MU GROUP CONSULTING

TECHNICAL NOTE

**State Significant Development at 884-928
Mamre Road, Kemps Creek**

Ref: P21_19_APP_Mamre_WAD_DD

APPENDIX A – Strategic Design - LILO with acceleration lane – TfNSW Ultimate Layout

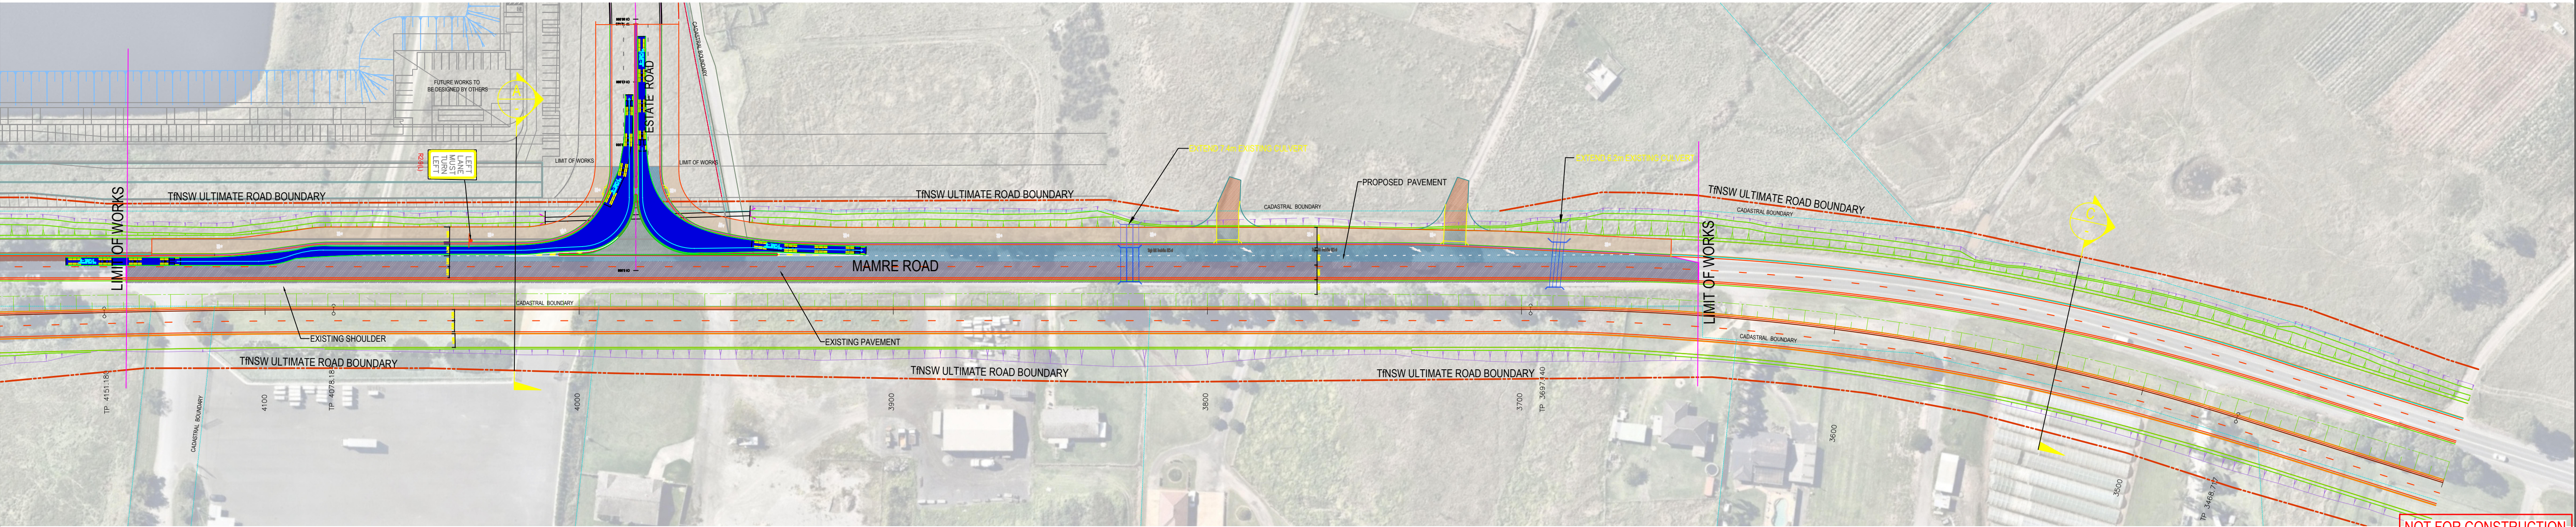
2. The design provided is unorthodox and there is nothing that requires a resident to use that arrangement. The cut-out in the median may also be mistaken as a refuge.

8. Design showing location of LILO with the ultimate Mamre Road upgrade alignment

The Design (Drawing No. 2021_19_SK_0007) has now been amended to remove cut-out in the median. An alternative arrangement to avoid the weaving movement is to allow the local traffic to enter the development site and use the internal roundabout (approximately 200m within the development) for a U-turn movement and exit via the acceleration lane to access their properties. Refer to attached **Appendix D**. This can be developed into a Local Access Plan for the private properties. It is noted that the volume of local traffic performing this manoeuvre is anticipated to be 2-4 vehicles per day.

The strategic design has been overlaid on the TfNSW Mamre Road "Ultimate" design. Refer to Drawing No. 2021_19_SK_0007. The plans show that the LILO is constructed outside the ultimate Mamre Road design footprint and includes a shared path that can tie up with the ultimate design following the merger.

APPENDIX B – Strategic Design - Swept Path of PBS Level 3 Type A Vehicle

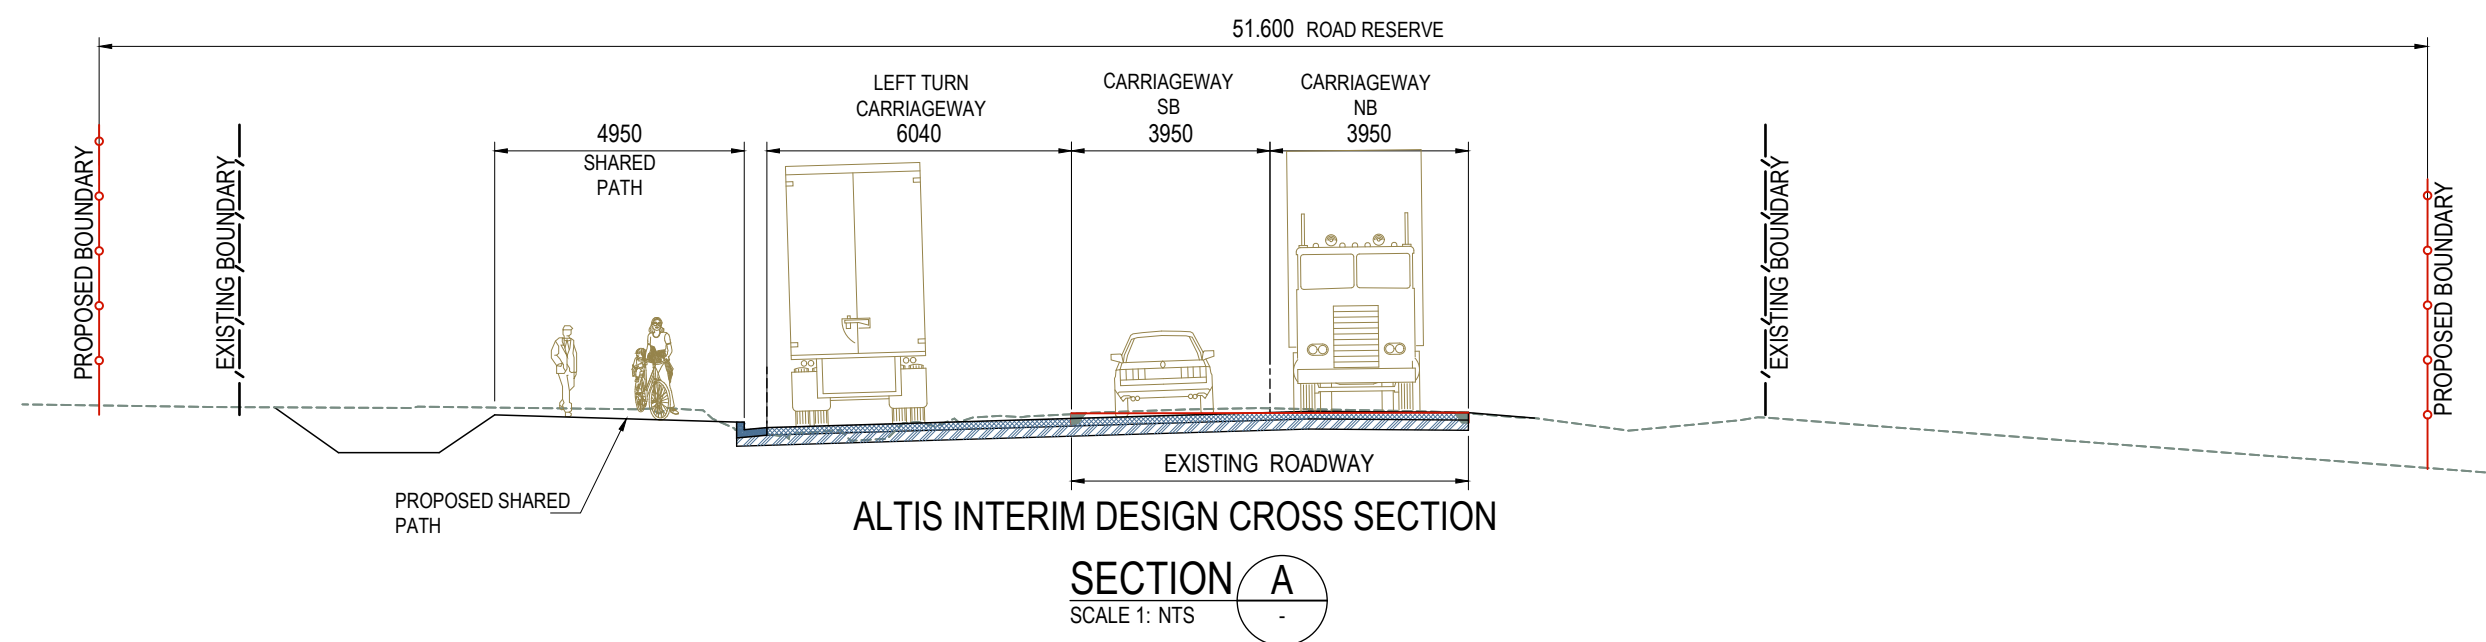
7. Swept paths of the longest vehicles simultaneous entry/exit in line with Austroads Std.

36.5m PBS Level 3 Type A vehicle has been adopted as the check vehicle to assess the swept path for simultaneous entry / exit. Swept path analysis is as shown on the plan attached in **Appendix B**.
